UNITED STATES PATENT AND TRADEMARK OFFICE

APPLICATION NO.	FILING DATE	FIRST NAMED INVENTOR	ATTORNEY DOCKET NO.	CONFIRMATION NO.
10/802,445	03/17/2004	Roman F. Striebel	6623-119	3528

Office Action Summary

DETAILED ACTION

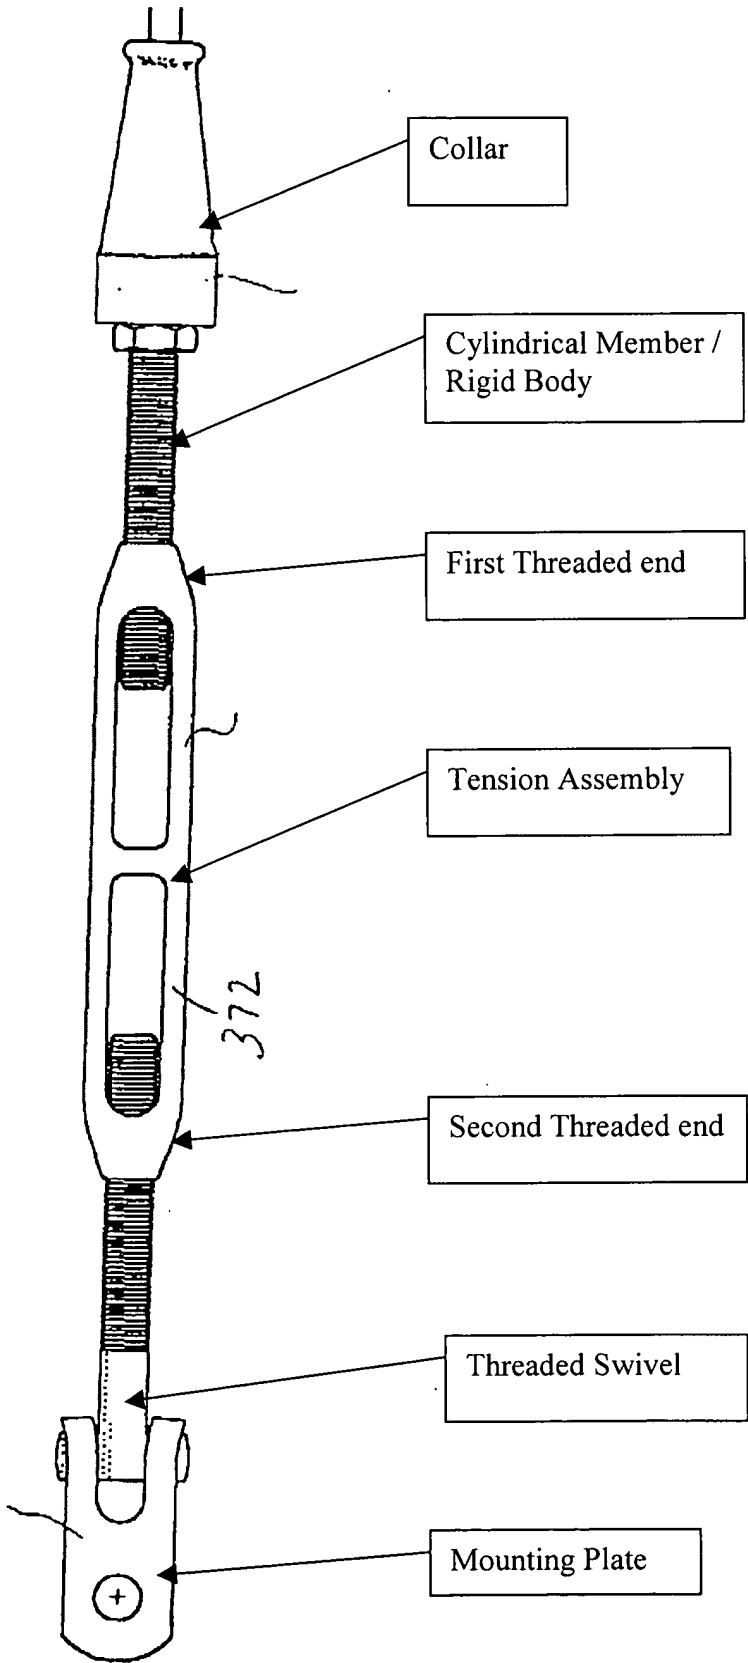
In regards to claims 1-6, 8 and 9, Sjostedt discloses a wire attachment assembly, comprising:

a collar 374 including a center aperture dimensioned to receive a portion of a wire, a threaded portion, and a tapered internal recess (see Figure 23, below);

a cylindrical member including a threaded end engaging the threaded portion of the collar; and

a tapered wedge-shaped unitary member disposed between the collar and cylindrical member.
